Alabama State Port Authority
Addendum to R&P or Specification Booklet

Project Name McDuffie Warehouse

Project No. 10861 **Task No.** 02 **Addendum No.** 2

Date: 9/9/2022

SECURITY PERIMETER PLAN

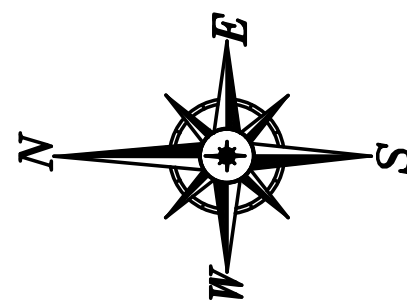
5.	Question: How long is the concrete gate track required to be? Will it be the 107'-0" dimension? Answer: The gate no longer has a track. See revised civil drawings included with Addendum #2 for revised gate and fence layout.

CONTRACTOR SHALL INSTALL NEW FENCE DIRECTLY ADJACENT TO EXISTING FENCE. NO MORE THAN A 4" GAP BETWEEN EXISTING AND NEW FENCE.

WINDOW SCHEDULE NOTES:

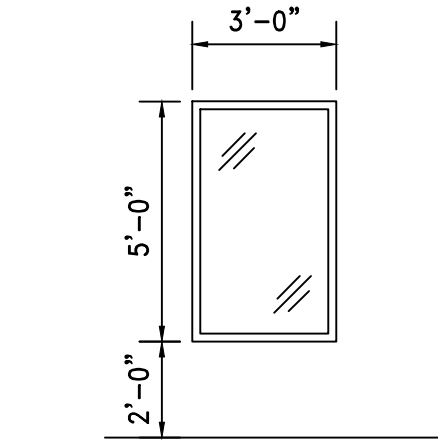
Item	Description
1.	The required U-Factor and SHGC value for windows has been revised on DWG. 4043-A6. DWG. 4043-A6 Rev B is attached and is hereby incorporated into the bid documents by this addendum.

1. CLEAR TEMPERED
2. IMPACT RESISTANT: 159 WIND REQUIREMENT MIN.
3. VINYL FRAME FIXED
4. U-FACTOR: 0.35
5. SHGC: 0.27
